# KEENE INFRASTRUCTURE IMPROVEMENTS **PHASE 2 PRELIMINARY DESIGN** **CENTRAL SQUARE**

MSFI COMMITTEE MEETING

MAY 08, 2024

# KEENE PHASE 2 | CENTRAL SQUARE DESIGN REVIEW WORKSHOP #3

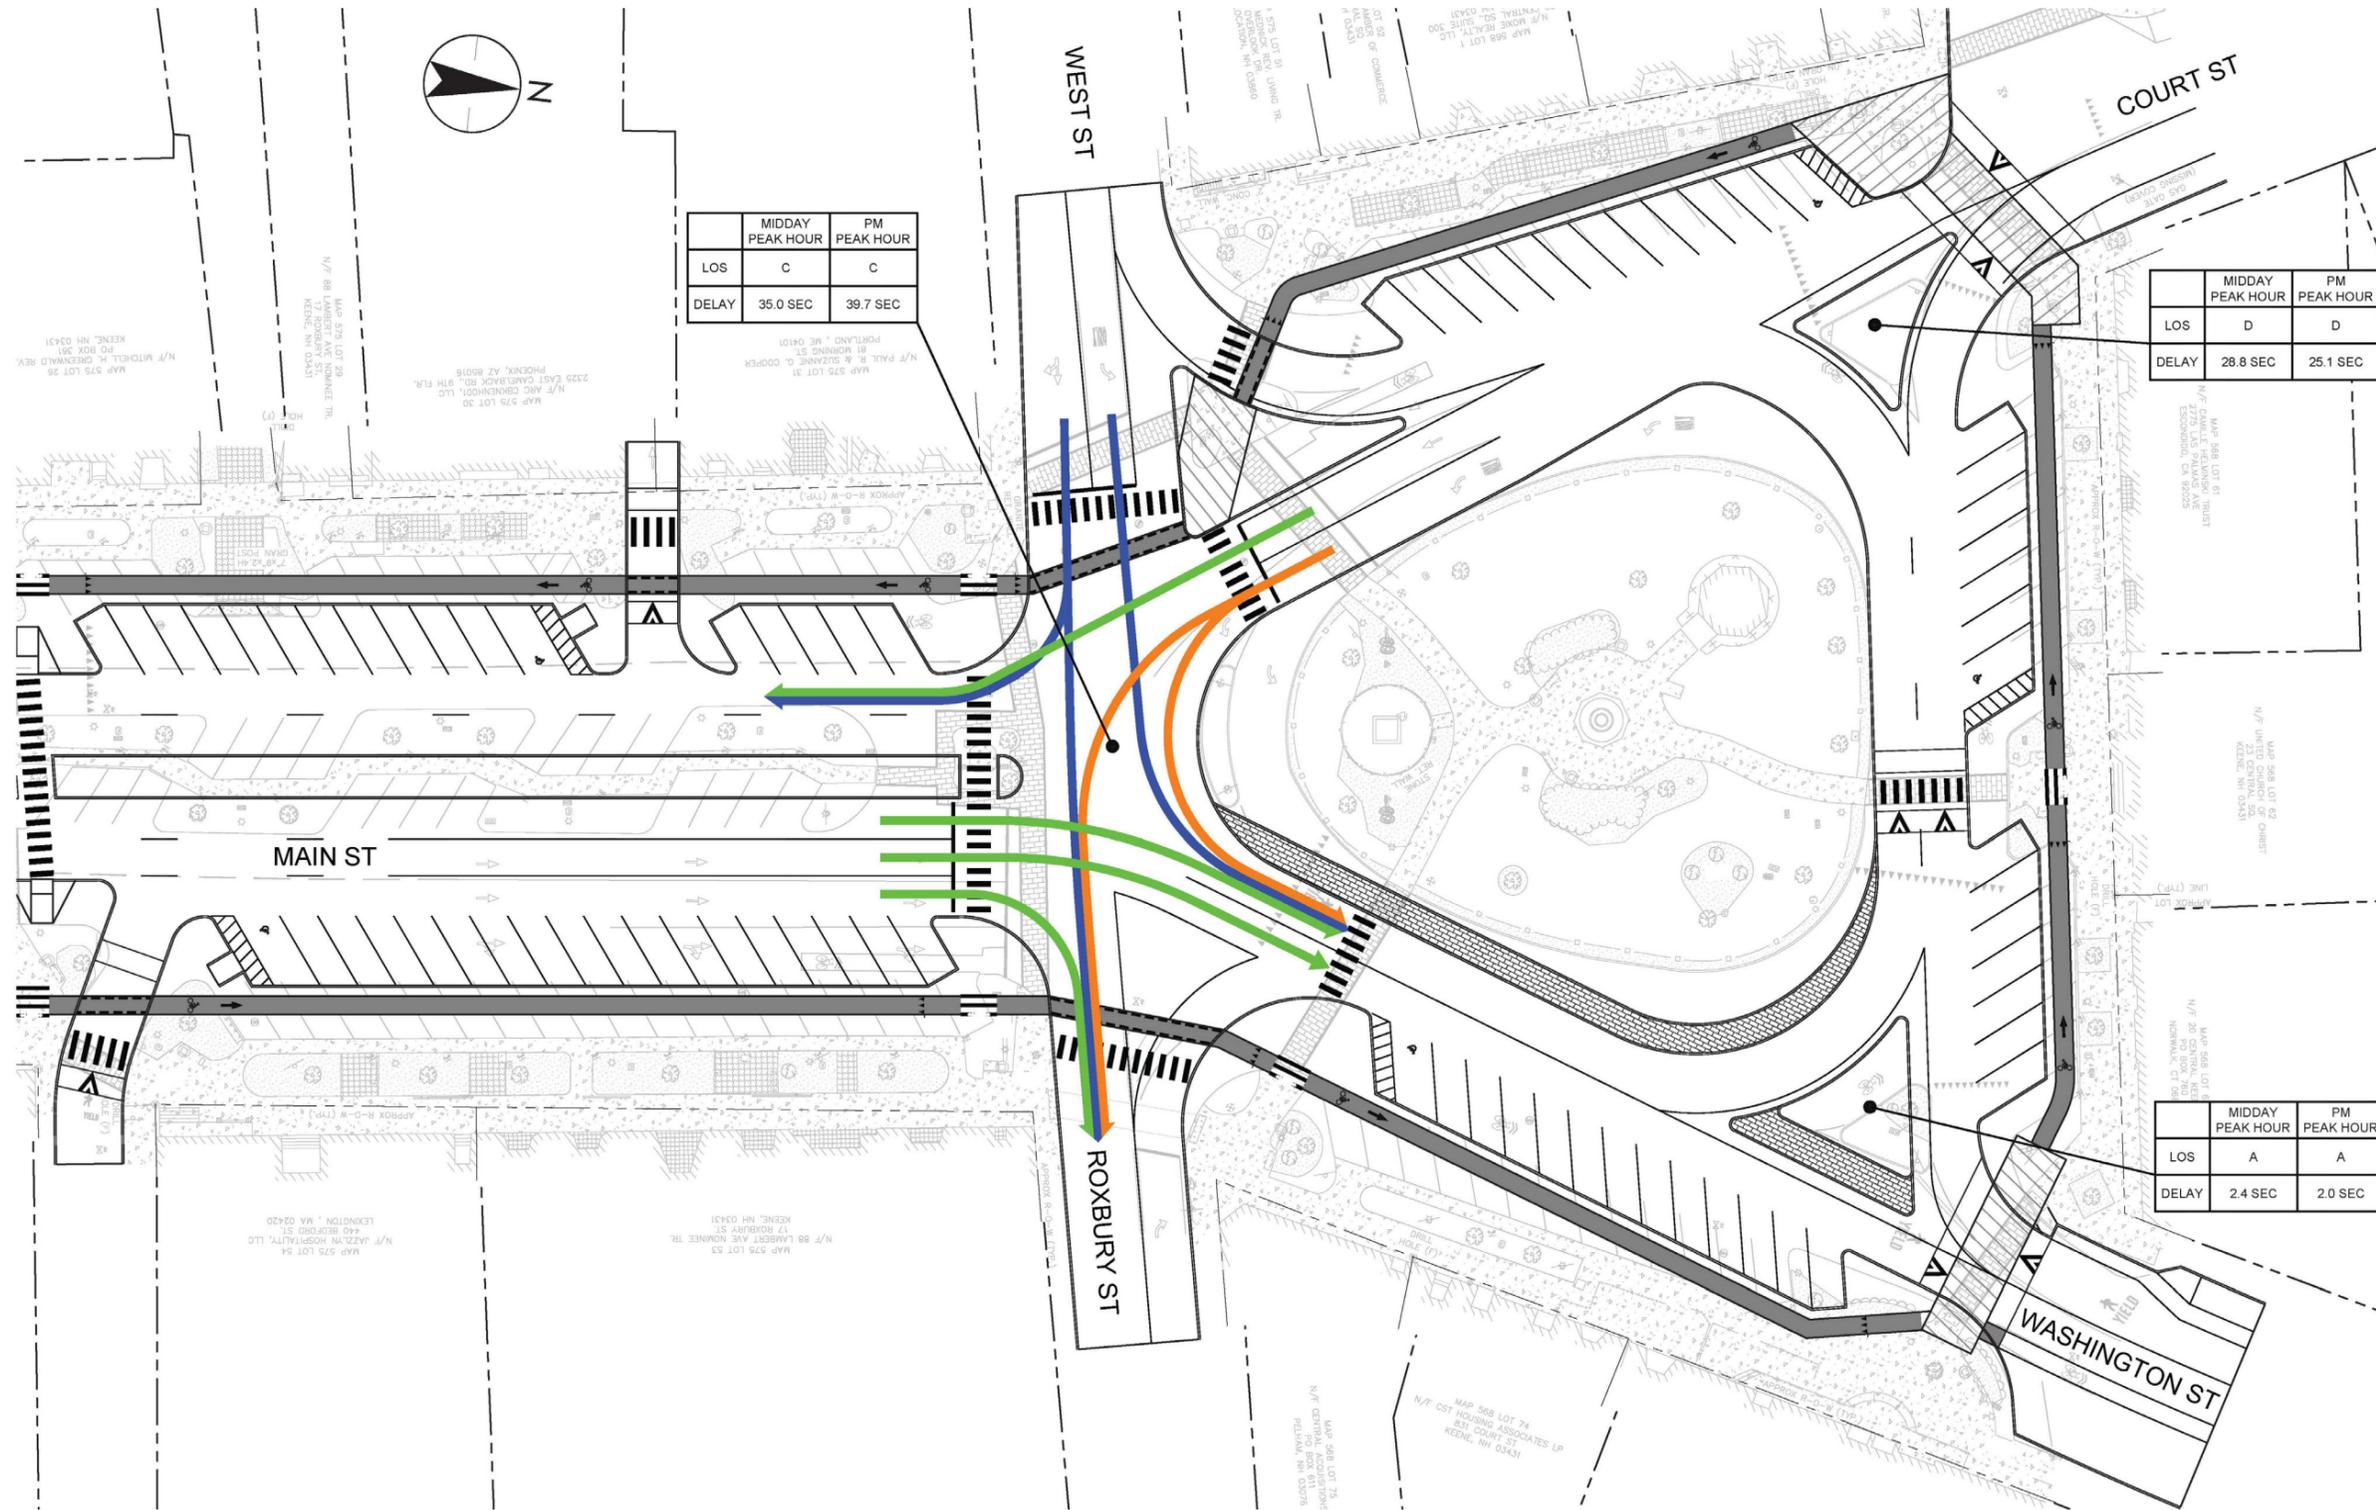
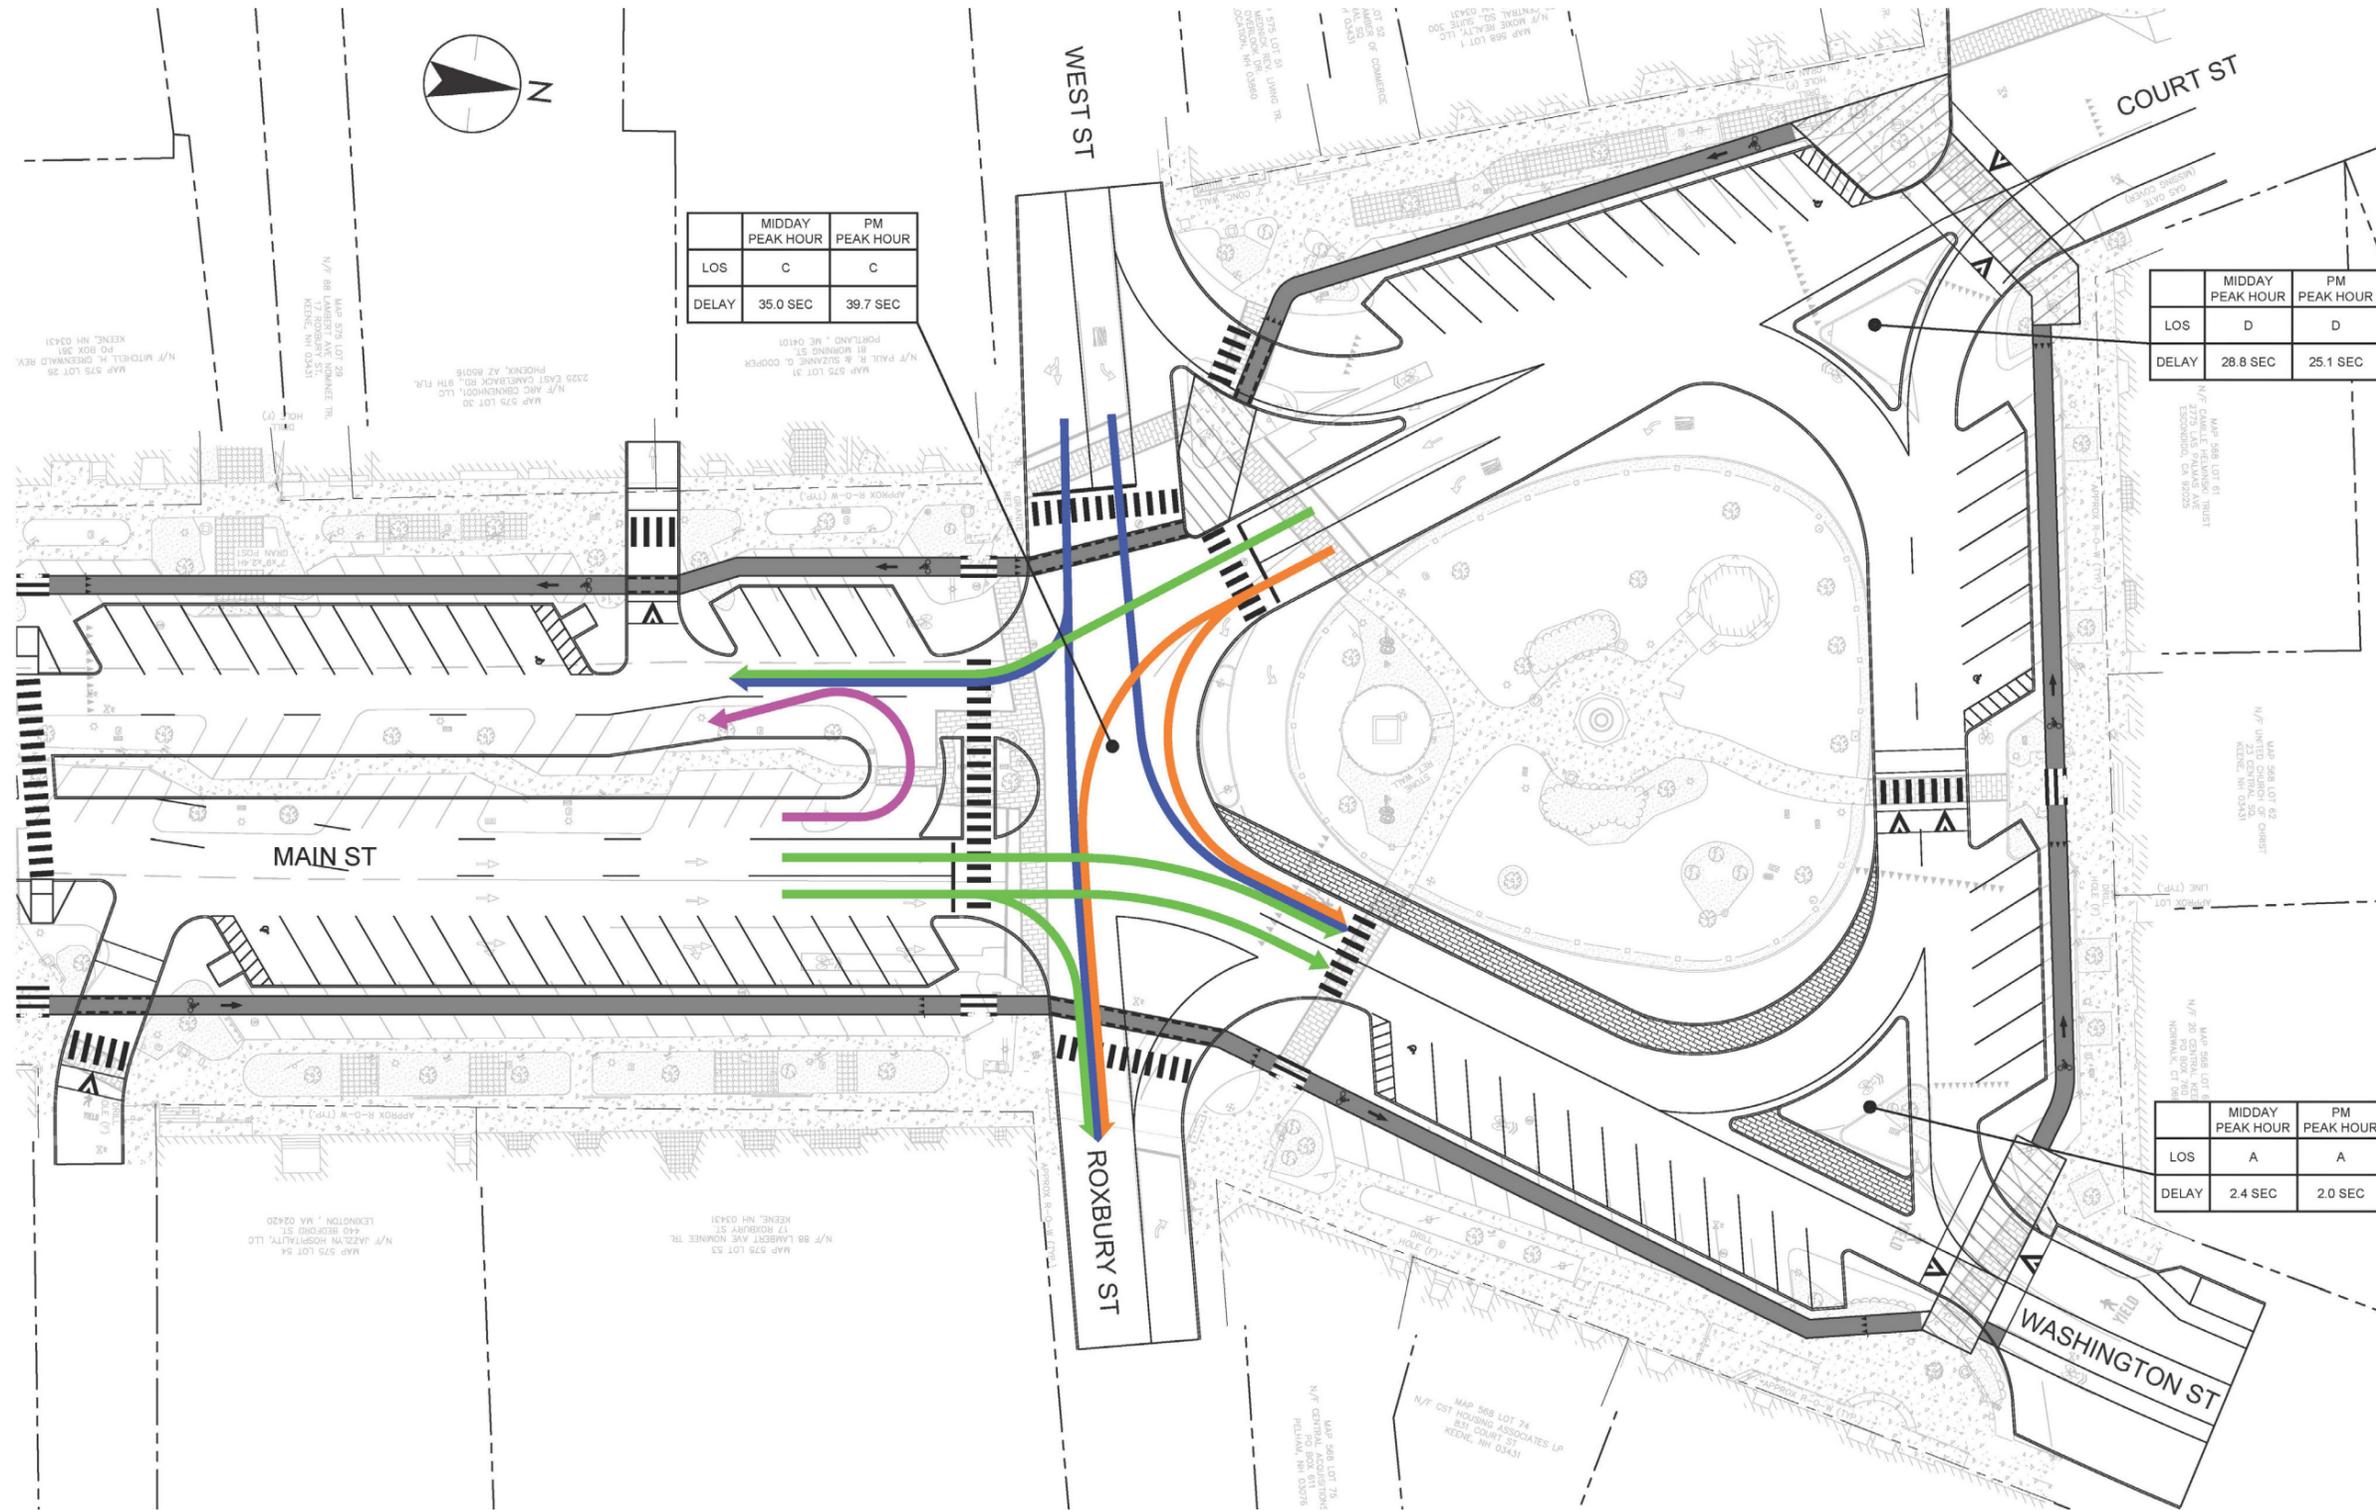
- The U-turn south of the intersection had the most support of the U-turn alternatives.
- The single/double lane across the top of the square was mixed, about 50/50 between the two alternatives.
- General concern that reducing from two southbound through lanes to one will create backups along Court and across the top of the Square.
- Strong support for the raised crosswalks and RRFB(Rectangular Rapid Flashing Beacon) as shown.
- Concern with reducing to a single left turn lane from crossover to Court/West Street.
